ARKANSAS  
Department of Environmental Quality

RE: NPDES Compliance Inspection; PLWC Wastewater Treatment Plant  
AFIN: 28-00470, NPDES Permit No.: AR0033766, ARR00C418

Re: NPDES Permit # AR0033766  
March 2013 Compliance Inspection Response Report

**Compliance Evaluation Inspection  
Sanitary Sewer Overflow Inspection  
Stormwater “No Exposure” Inspection  
Pretreatment Compliance Inspection**

SECTION — GRIT CHAMBER REPLACEMENT

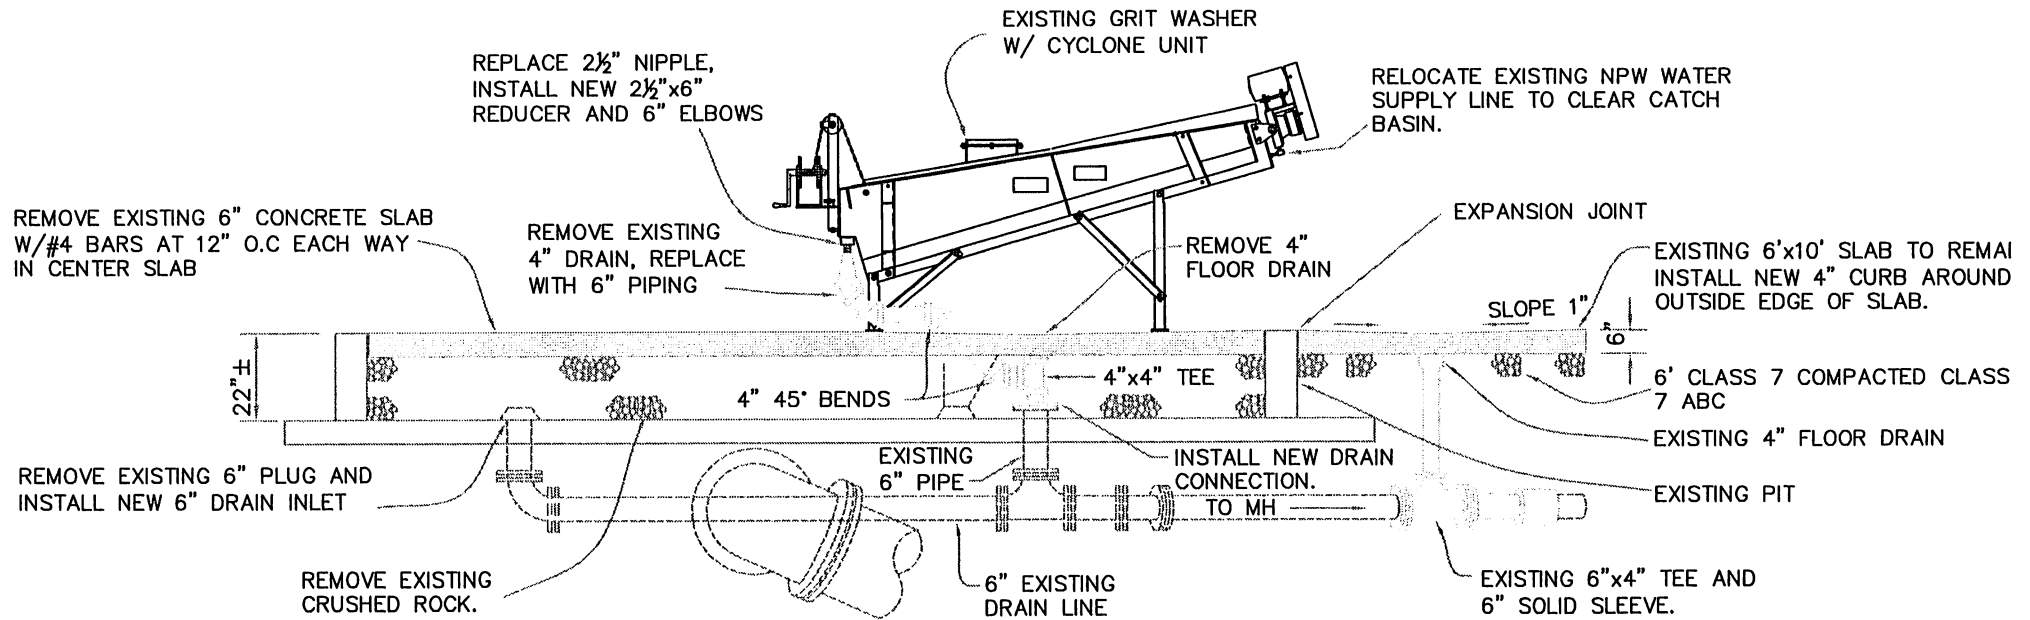
There were sewage residues on the ground near the grit chamber. These residues were exposed to stormwater and therefore violate the conditions of the no exposure certification.

Sewage residues have been cleaned from the grit chamber area. To prevent further instances, the PLWC Engineering Department has determined there is an existing concrete pit 22 inches deep located under the present floor supporting the grit washer unit. The current six inch concrete floor will be removed to take back the original pit floor. Posts will be constructed to allow the grit classifier to sit on the floor of the pit. In addition, the drain for the area will be increased from four inches to six inches to allow for drainage. This project will commence as soon as the weather allows. See the enclosed diagrams for details of the proposed plan.

CONSTRUCT ADEQUATE CONCRETE BASE SUPPORTS UNDER EACH OF THE UNITS STEEL FEET. BASE TO BE 2" LARGER IN ALL HORIZONTAL DIMENSIONS WITH 45 DEGREE CHAMFER. ELEVATIONS TO MATCH EXISTING. PROVIDE ANCHOR BOLTS.

REPLACE EXISTING ELECTRICAL SERVICE TO FOLLOW EXISTING SURFACES AFTER SLAB IS REMOVED. LOCATE TO NOT BE A TRIP HAZARD. ANCHOR AS REQUIRED.

SECTION - GRIT CHAMBER REPLACEMENT

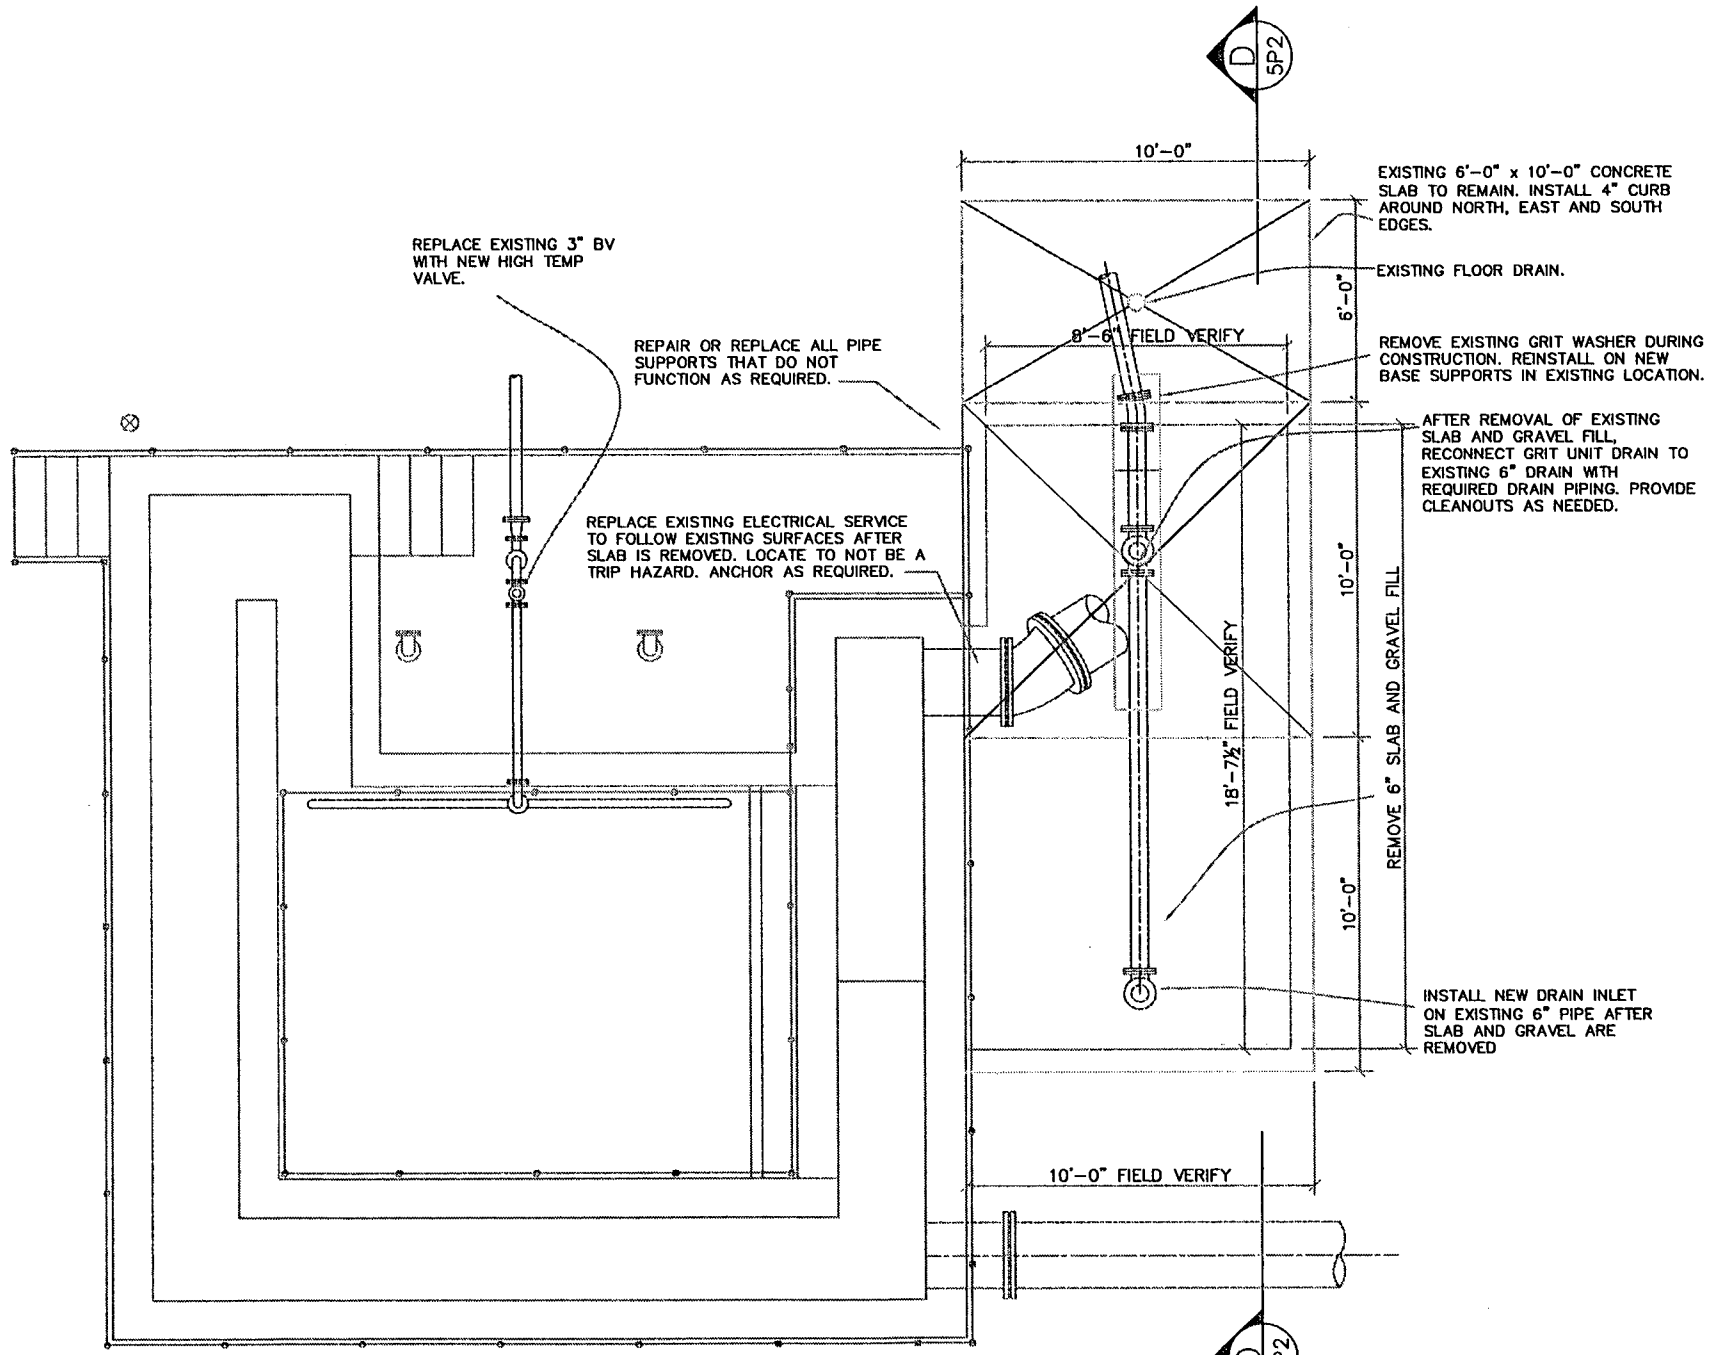
There were sewage residues on the ground near the grit chamber. These residues were exposed to stormwater and therefore violate the conditions of the no exposure certification.

Sewage residues have been cleaned from the grit chamber area. To prevent further instances, the PLWC Engineering Department has determined there is an existing concrete pit 22 inches deep located under the present floor supporting the grit washer unit. The current six inch concrete floor will be removed to take back the original pit floor. Posts will be constructed to allow the grit classifier to sit on the floor of the pit. In addition, the drain for the area will be increased from four inches to six inches to allow for drainage. This project will commence as soon as the weather allows. See the enclosed diagrams for details of the proposed plan.

CONSTRUCT ADEQUATE CONCRETE BASE SUPPORTS UNDER EACH OF THE UNITS STEEL FEET. BASE TO BE 2" LARGER IN ALL HORIZONTAL DIMENSIONS WITH 45 DEGREE CHAMFER. ELEVATIONS TO MATCH EXISTING. PROVIDE ANCHOR BOLTS.

REPLACE EXISTING ELECTRICAL SERVICE TO FOLLOW EXISTING SURFACES AFTER SLAB IS REMOVED. LOCATE TO NOT BE A TRIP HAZARD. ANCHOR AS REQUIRED.

REPLACE EXISTING 3" BV WITH NEW HIGH TEMP VALVE.

REPAIR OR REPLACE ALL PIPE SUPPORTS THAT DO NOT FUNCTION AS REQUIRED.

REMOVE EXISTING GRIT WASHER DURING CONSTRUCTION. REINSTALL ON NEW BASE SUPPORTS IN EXISTING LOCATION.

AFTER REMOVAL OF EXISTING SLAB AND GRAVEL FILL, RECONNECT GRIT UNIT DRAIN TO EXISTING 6" DRAIN WITH REQUIRED DRAIN PIPING. PROVIDE CLEANOUTS AS NEEDED.

REMOVE 6" SLAB AND GRAVEL FILL
